Access Compliance Report

Public Rights-of-Way

(Curb Ramps)

Intersection ID: 48492	Main Street: SHOPTON_RD_WEST	Cross Street: BEREWICK_COMMONS_PY	Location: SE
ADA ID: D5D530384AC5	Ramp Type: Perp	Initial Pass/Fail: Fail	Overall Compliance: No
Severity Score: 13.75			
Codes/Mitigation Info/Possible Solution		Field Measurements/Component Compliance

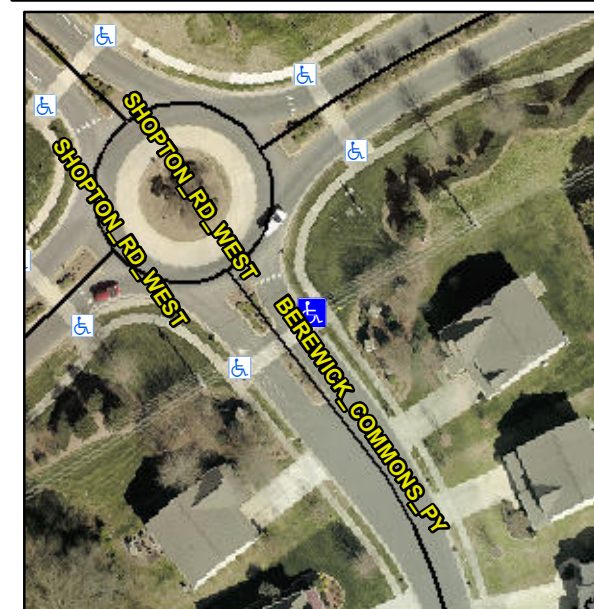
Not Found, R304.2.2, R304.5.3

Compliance	Description	Data	Compliance	Description	Data
N/A	Ramp Length (in)	57.0	No	Ramp Slope (%)	8.8
Yes	Ramp Width (in)	48.0	No	Ramp XSlope (%)	3.0
N/A	Flare Type LT	N/A	N/A	Flare Type RT	N/A
N/A	Flare Slope LT (%)	N/A	N/A	Flare Slope RT (%)	N/A
N/A	Flare Traversable LT?	N/A	N/A	Flare Traversable RT?	N/A
N/A	Landing Length (in)	N/A	N/A	DWS Provided?	N/A
N/A	Landing Width (in)	N/A	N/A	DWS Contrast?	N/A
N/A	Landing Slope (%)	N/A	N/A	DWS Length (in)	N/A
N/A	Landing X Slope (%)	N/A	N/A	DWS Full Width?	N/A
N/A	Landing Curb? (Y/N)	N/A	N/A	DWS Offset (in)	N/A
N/A	Shared Landing?	N/A			
N/A	Gutter Ponding?	N/A	N/A	Gutter Slope (%)	N/A
N/A	Gutter Lip Ht (in)	N/A	N/A	Gutter X Slope (%)	N/A
N/A	Painted X Walk1?	Yes	N/A	Painted X Walk2?	N/A
	X Walk 1 Direction	To SW		X Walk 2 Direction	N/A
N/A	X Walk 1 Width (in)	96.0	N/A	X Walk 2 Width (in)	N/A
	X Walk 1 Slope (%)	1.8		X Walk 2 Slope (%)	N/A
	X Walk 1 X Slope (%)	2.6		X Walk 2 X Slope (%)	N/A

Remove & Replace Entire Ramp.
